To: Bassett Creek Watershed Management Commission
From: Barr Engineering Co.
Subject: Item 5D. Consider Approval of 90% Plans for Honeywell Pond Expansion Project (BC-4), Golden Valley
BCWMC November 18, 2015 Meeting Agenda
Date: November 11, 2015
Project: 23270051 2015 632

5D. Consider Approval of 90% Plans for Honeywell Pond Expansion Project (BC-4), Golden Valley

Basis for Commission Review: 90% Design Review

SHEET
172
 OF
340
 SHEETS

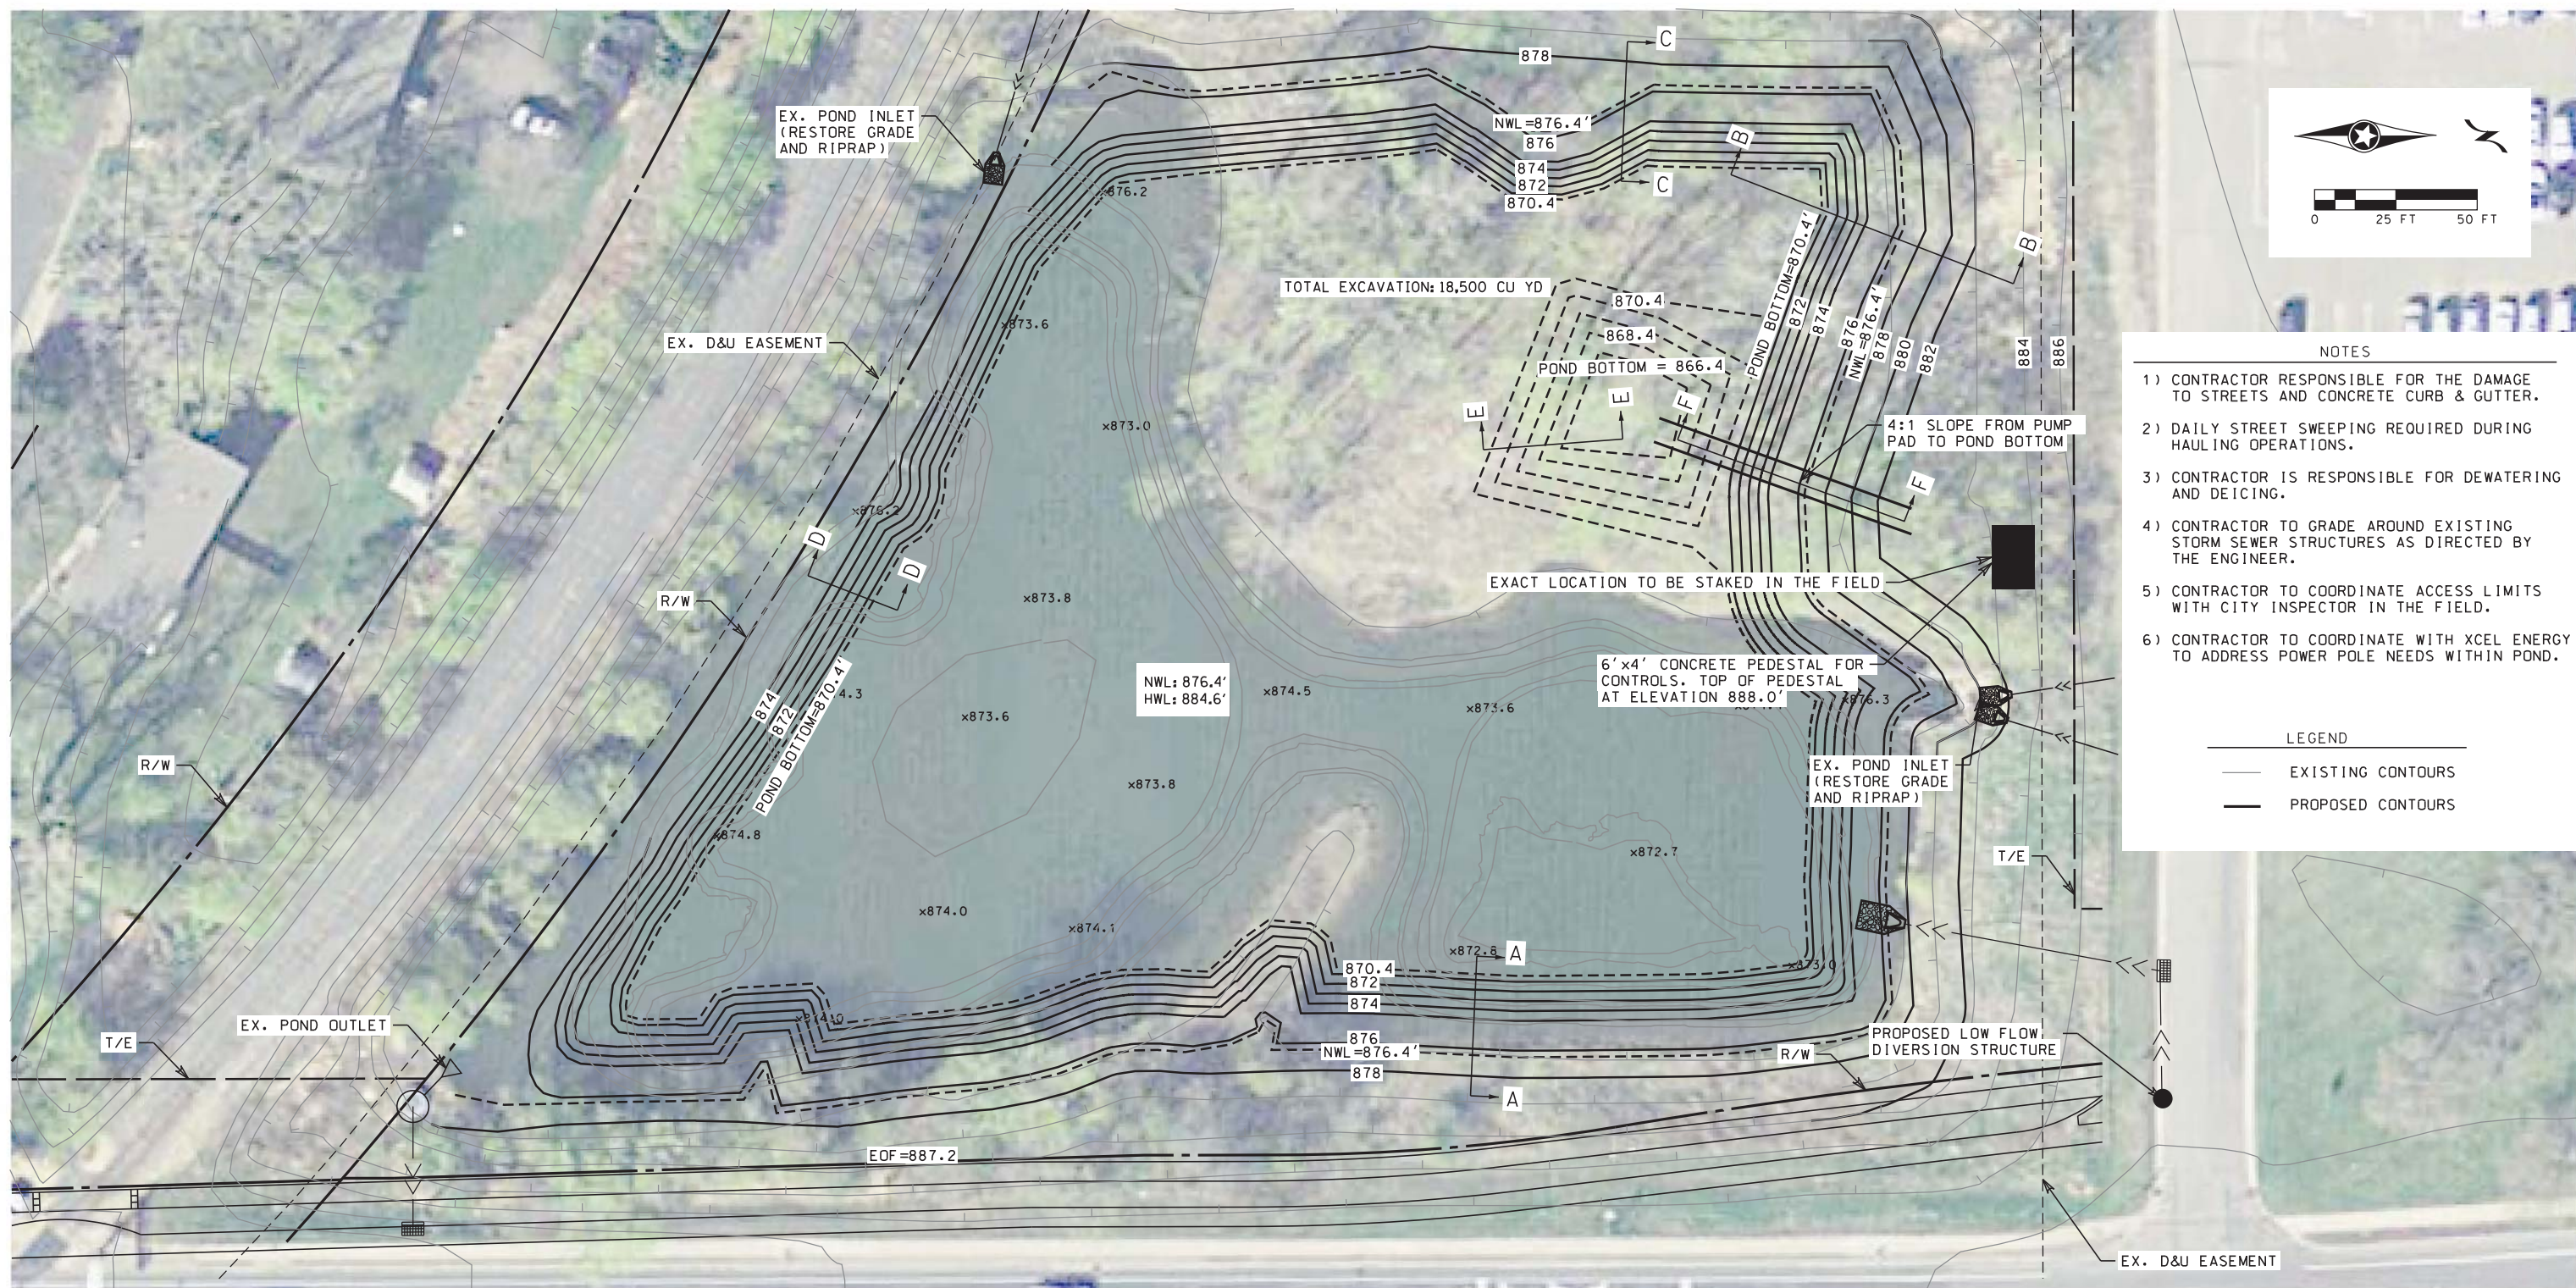
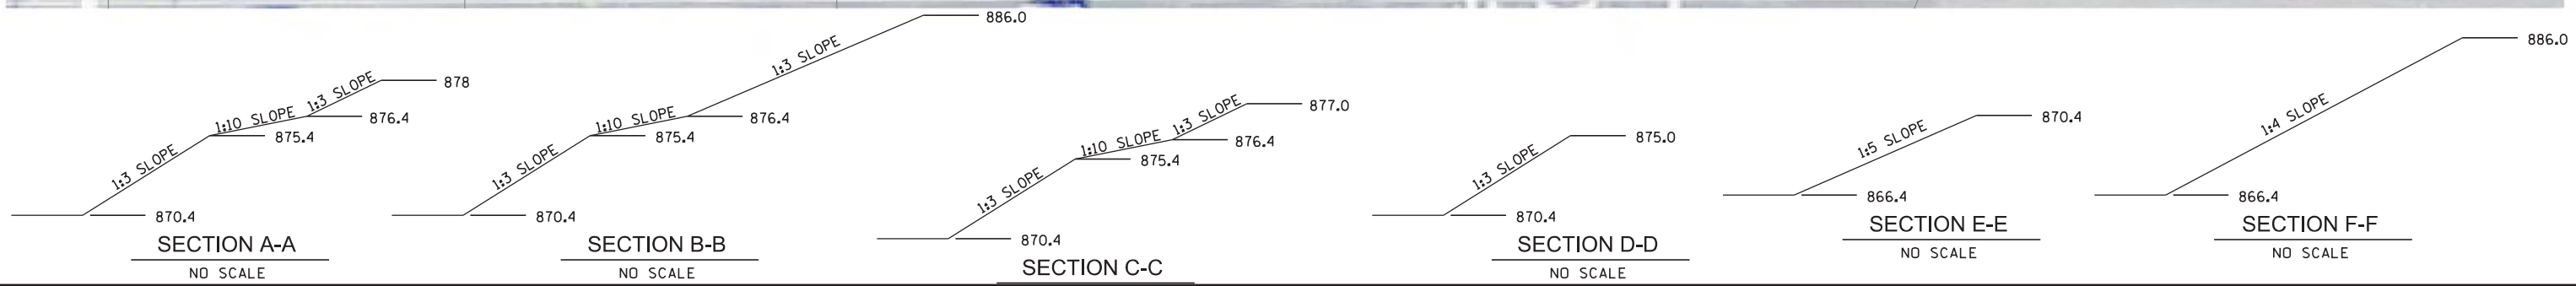
- a. Erosion control details must be shown on the plans. The SWPPP indicates the details are on Sheet 10, which does not appear to have been provided in the submittal.
- b. The erosion control plan showing the location of proposed erosion control devices must be provided for review. The SWPPP indicates this is on Sheets 218-222, which do not appear to have been provided in the submittal.
- c. The erosion and sediment control plan must incorporate the following notes and features:
 - i. Temporary or permanent mulch must be uniformly applied by mechanical or hydraulic means and stabilized by disc-anchoring or use of hydraulic soil stabilizers.
